So I could be sure I understand the proposed rules and meanings at unsignalized intersections I provided a few example intersections and received answers to my questions.

In the sample intersections below, how does one tell the difference between ‘constructed and painted islands’. The Legend on page 4 of the Functional Plan for Whitehorse Corridor Alaska Highway left this out. It would seem to be around the thick and thin black lines? As well, the diagrams on the last page of the plan shows measurements but not for the sizes of islands.

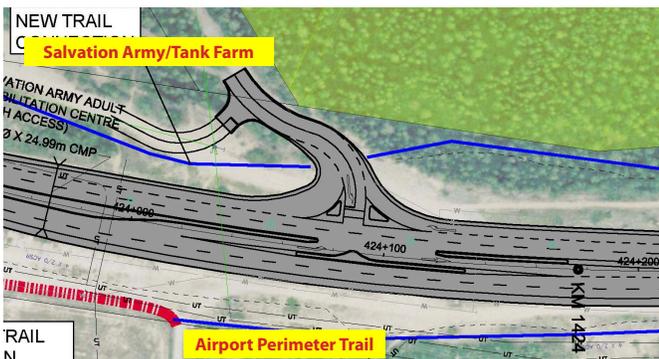
The legend is also not clear as to the markings for the center divider area of the proposed highway. When is there a center median with ‘barrier’ vs no center median?

*The drawings shows constructed and painted islands. **Specific provision for pedestrian crossing of the highway has not been made at Dawson Road.** During the next design phase, an assessment will be made of existing pedestrian volumes and requirements for pedestrian connectivity in the area to determine the warrants for a pedestrian crossing at this location. The assessment will be made in accordance with guidelines developed for the Yukon Government.*

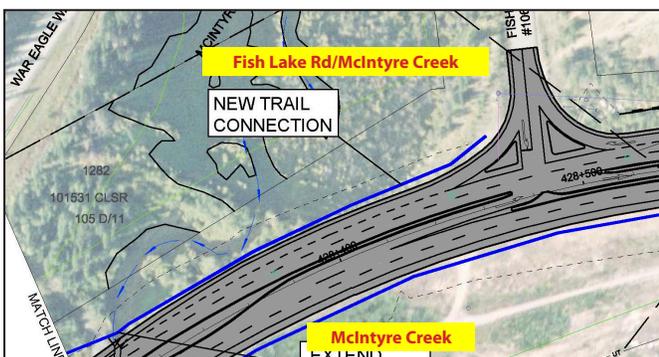
Each of the three samples had a different answer as to whether pedestrian crossing will be entertained in future processes. My time to sit at Highways and ask questions is limited. Someone has volunteered to apply to get a copy of the guidelines using the ATIPP process but this takes time in an already tight public process. In the meantime, could someone please use the guidelines to explain these examples?

*“The Salvation Army Pedestrian crossing of the highway is **not proposed at this location.** Pedestrian crossing points will be at either Hillcrest Drive or Two Mile Hill. Access to these locations will be facilitated by the continuation of the trail system each side of the highway.”*
